**Subject: RICE SOLAR ENERGY, LLC'S RESPONSES TO SUPPLEMENTAL DATA REQUESTS
RICE SOLAR ENERGY PROJECT
DOCKET NO. (09-AFC-10)**

Rice Solar Energy LLC's Responses to Supplemental Data Requests

August 6, 2010

Figure 29

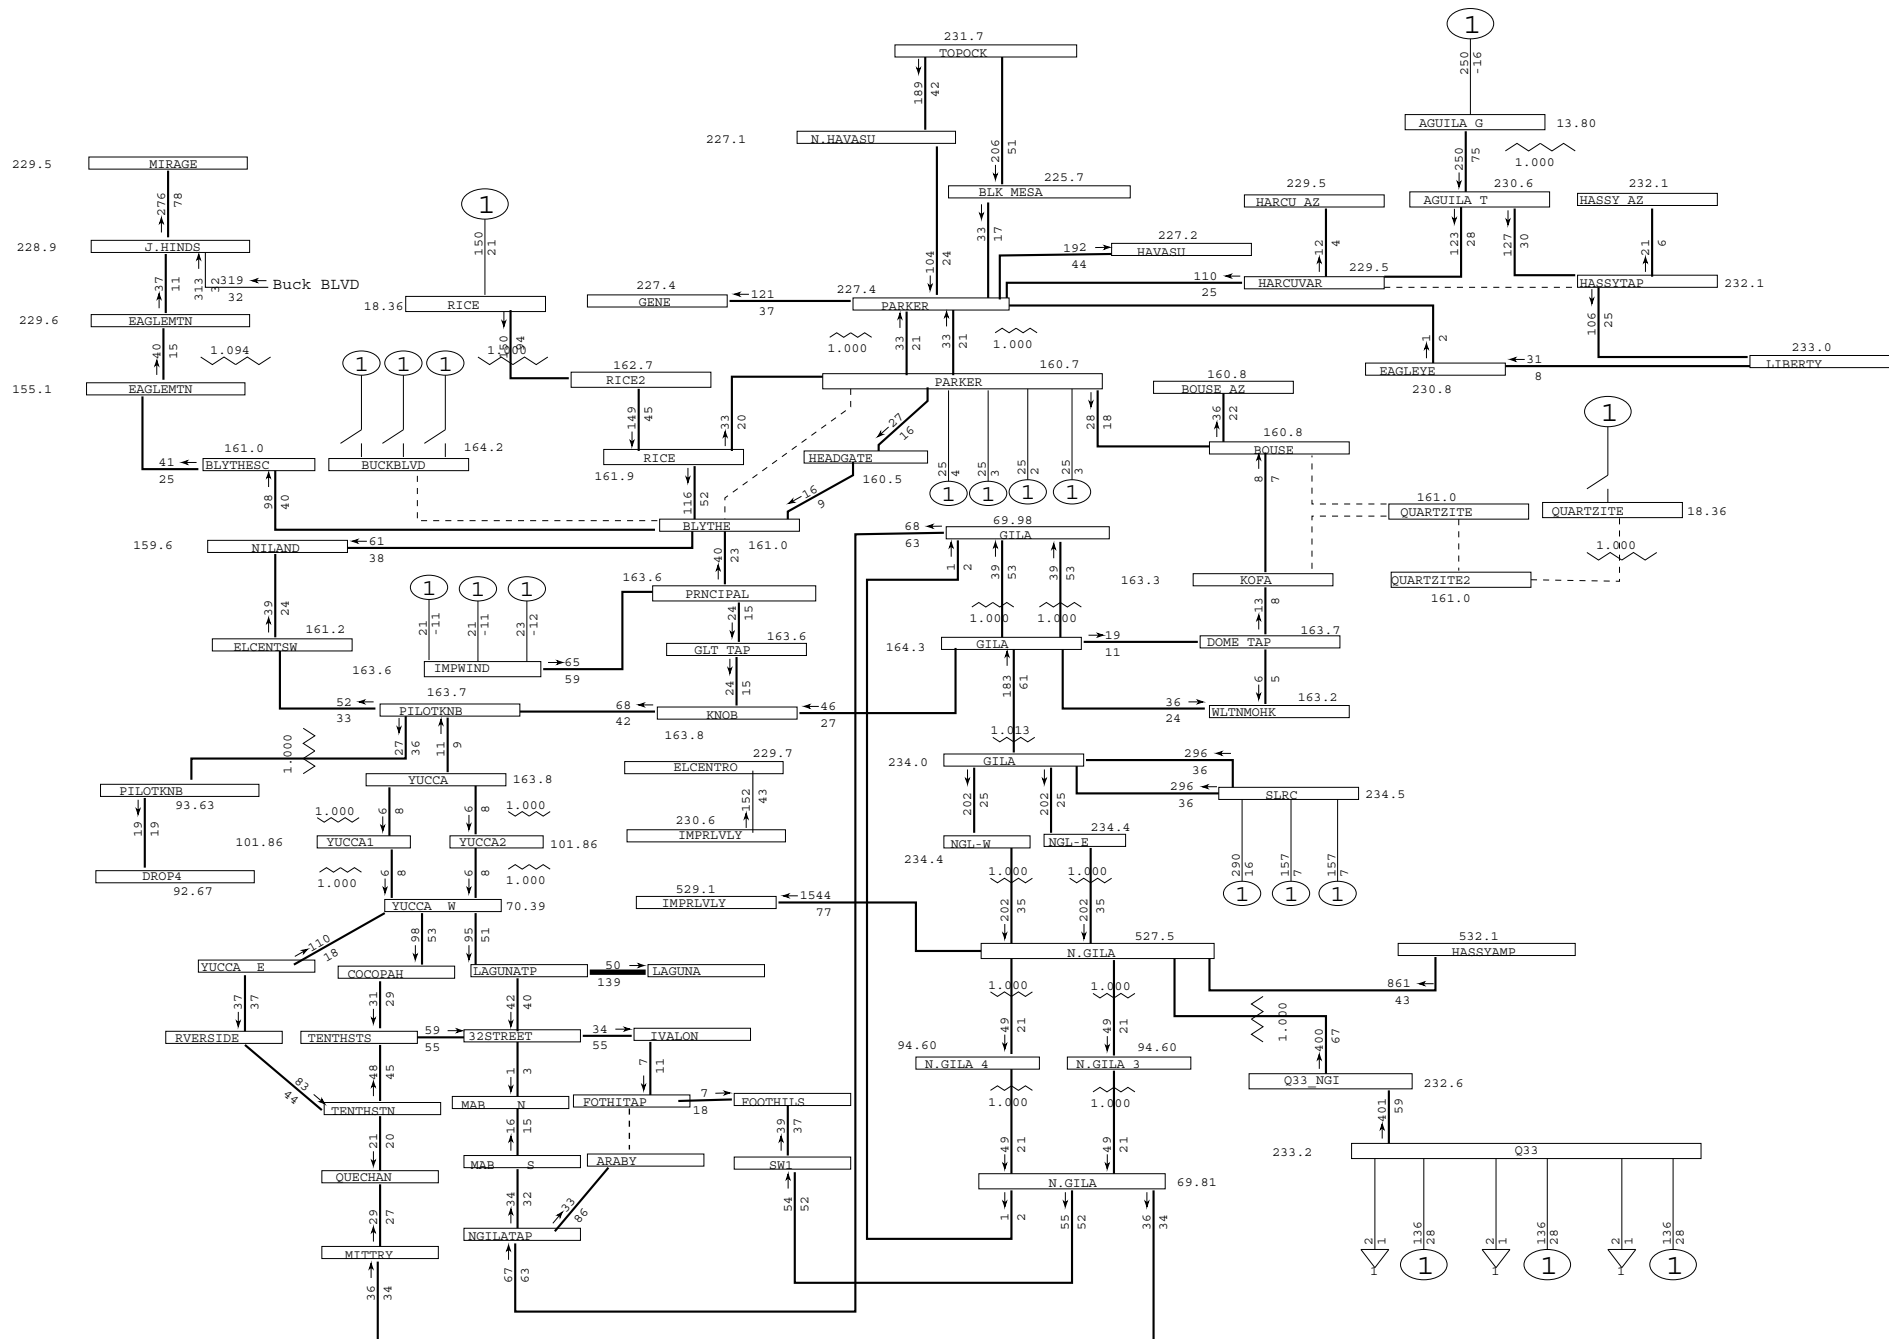
- 3) 13 HS Base Case with Quartzsite Gen on:
 - a. Load flow diagram for the Base Case with RICE ON – [Included in Figure 29](#)
 - b. Load flow diagram for Category B outage of the N. Gila-IV 500kV line – [Included in Figure 30 \(Pre-Project\) & 31 \(Post-Project\) Only the worst overload was shown on the table for the Knob-Pilot Knob area similar to item 1c above.](#)

Figure 37

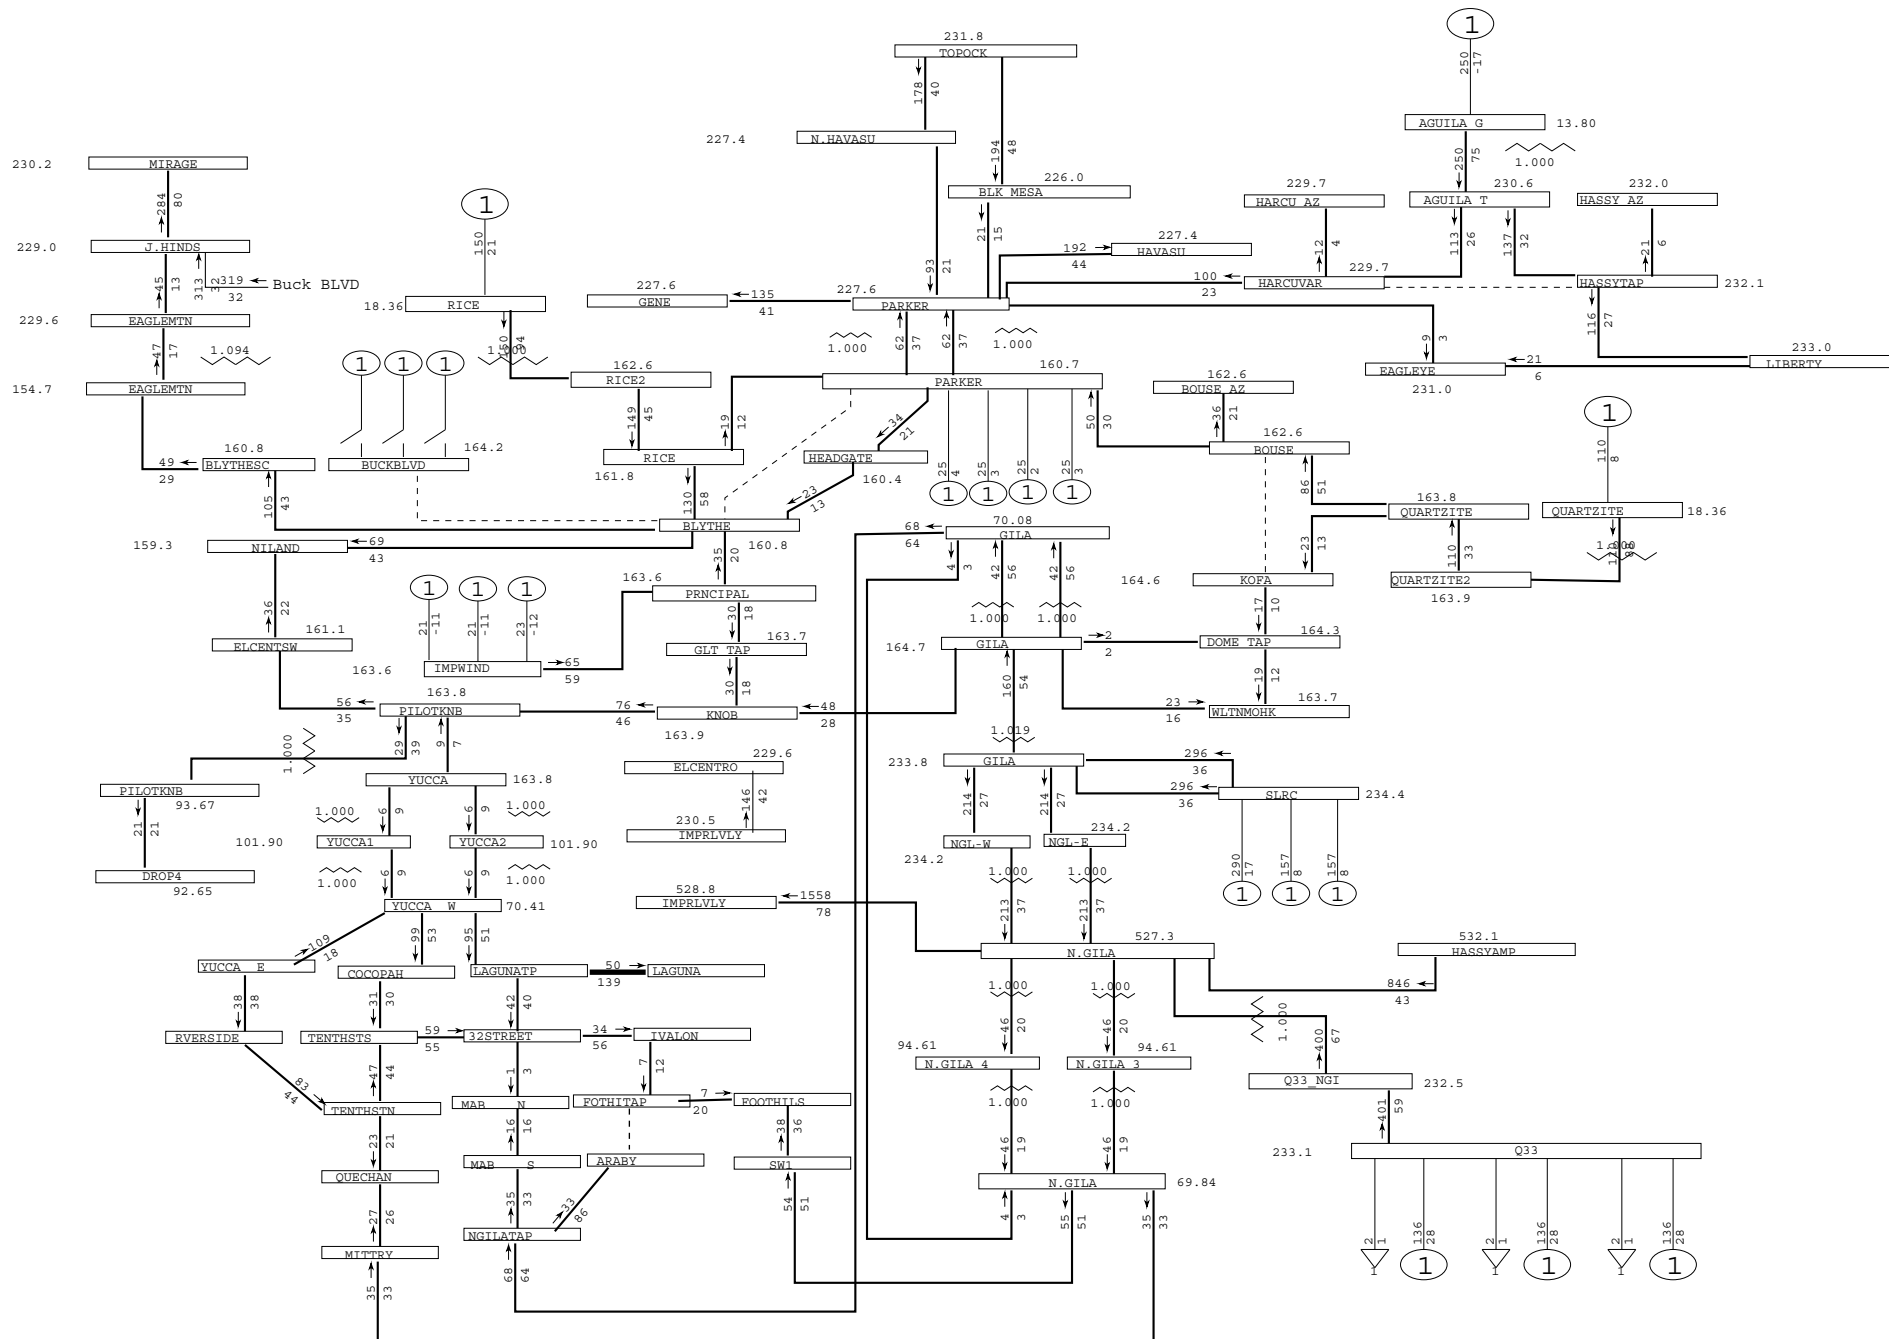
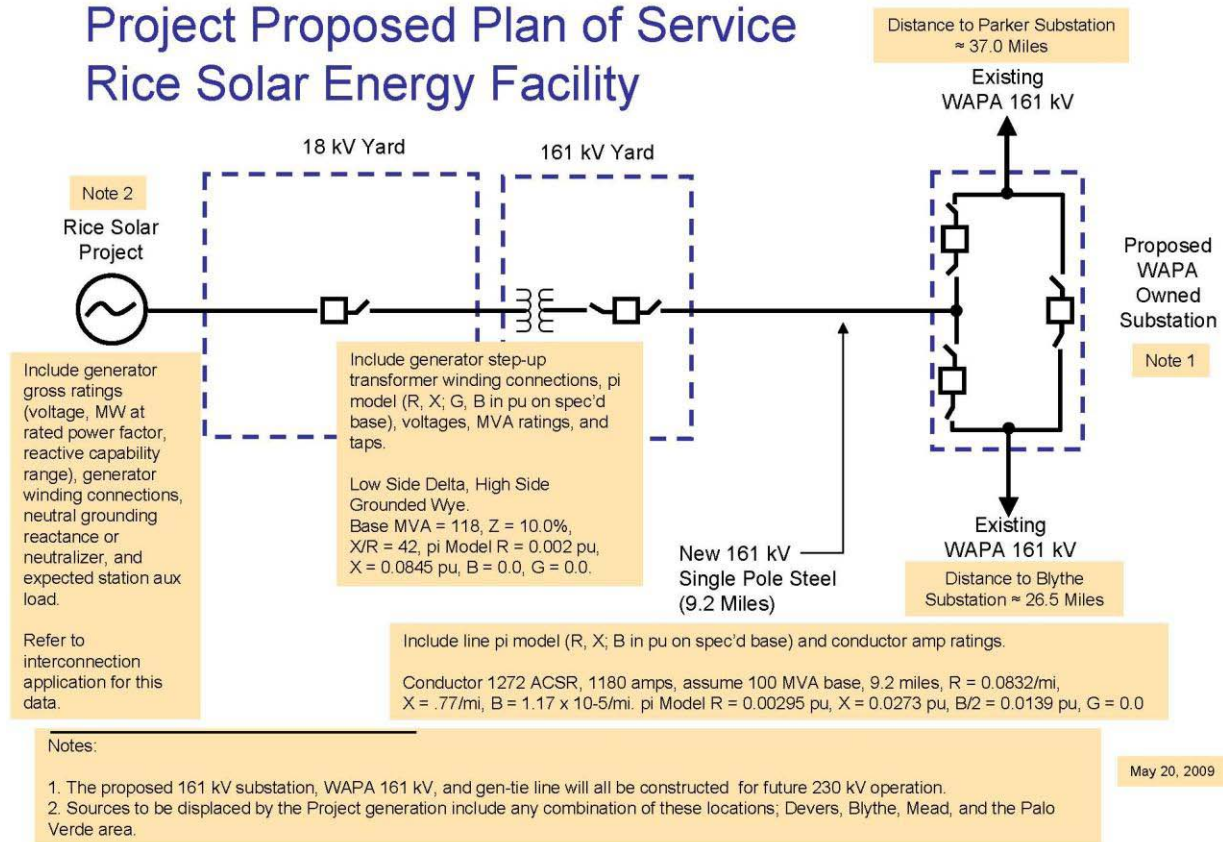
- b. Mention of show in a one-line diagram the major interconnection details modeled for the RICE Solar Energy project (RSEP) to the Western grid (such as amount of net RSEP generation, the step-up transformer size and impedance, mileage of the new Gen Tie line and size of its conductor, lengths of the existing Parker-Blythe 161 kV line from Blythe and Parker substations respectively to the proposed new RICE substation point of interconnection. – [Included in Figure 37](#)
